Staff Report to the Zoning Administrator

Application Number: **07-0117**

Project Description: Proposal to demolish an existing single-family residence on two lots (043-161-57 & -58), to construct one single-family residence of about 5,000 square feet with an attached garage on parcel 043-161-58, and to remove one 18" diameter tree.

Location: Project located at the southern end of Bayview Drive, on the site of 660 Bayview Drive.

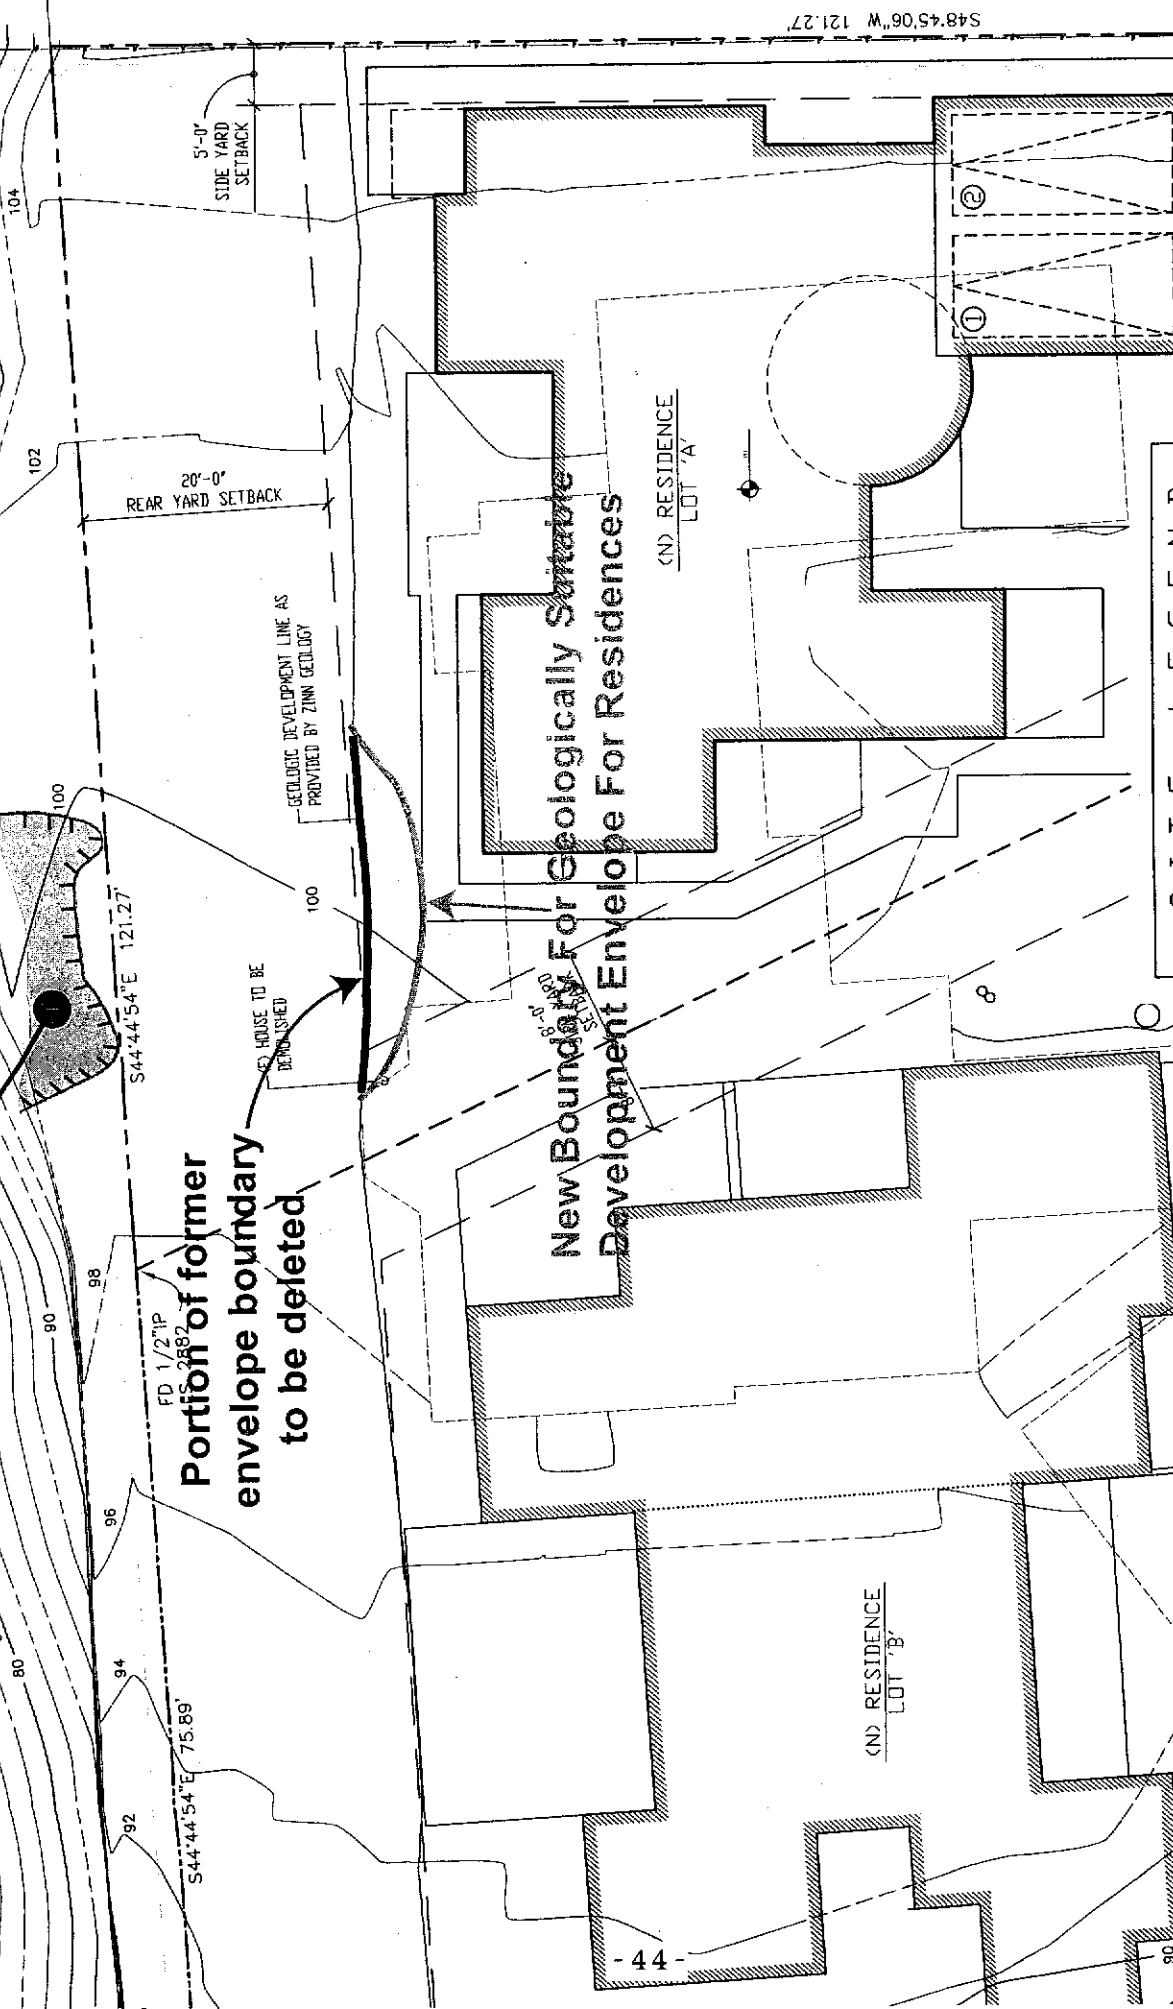
mind, we turn to Plate 1 accompanying this letter, where we have annotated our original geology building envelope based upon this recent event. As may be noted on Plate 1, we have pushed our original building envelope landward from the bluff with a concave polygon that is as much 9 feet inland from our original envelope boundary. *It is important to note that our original envelope, based upon our long-term bluff retreat rate calculations, took this landslide event into account.* Our subsequent modification of the envelope in this instance is a conservative measure taken as a result of our client's request.

As should be noted, the revised building envelope has no impact whatsoever upon the proposed residence for Lot B. Our professional opinion continues to be unchanged from our initial assessment - there is no geological basis for this event to impede the planning process for your project on this parcel.
